**SECOND DESIGN REVIEW RECOMMENDATION MEETING  
OF  
COMBINED DOWNTOWN DESIGN REVIEW BOARD &  
SEATTLE DESIGN COMMISSION**

**August 12, 2008**

**Project Number:** 3007149

**Address:** 601 Fourth Avenue

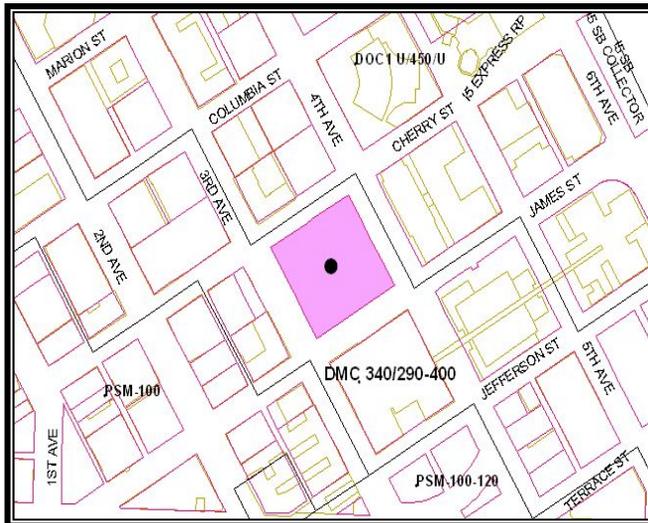
The presenter at the second Recommendation meeting identified several significant changes to the plaza and the structures surrounding it. The form of the tower's western base evolved in plan to mirror the eastern half, forming entries into the tower from both Cherry St. and the plaza at the mid-point of the tower plan. Aligned with the crease, which visually separates the office mass into two vertical halves, the new entry points gave reason to shift the circular center of the plaza toward the east and to reduce modestly the number of terraces ringing the amphitheatre. The breezeway evolved from a grand interior promenade along the north south axis to a hallway aligned with the exterior creases above the plaza and Cherry St. In place of the breezeway, a

public atrium would occupy the southern portion of the eastern tower block overlooking the plaza. Its advantages include an adjacency to the plaza and a southern exposure.
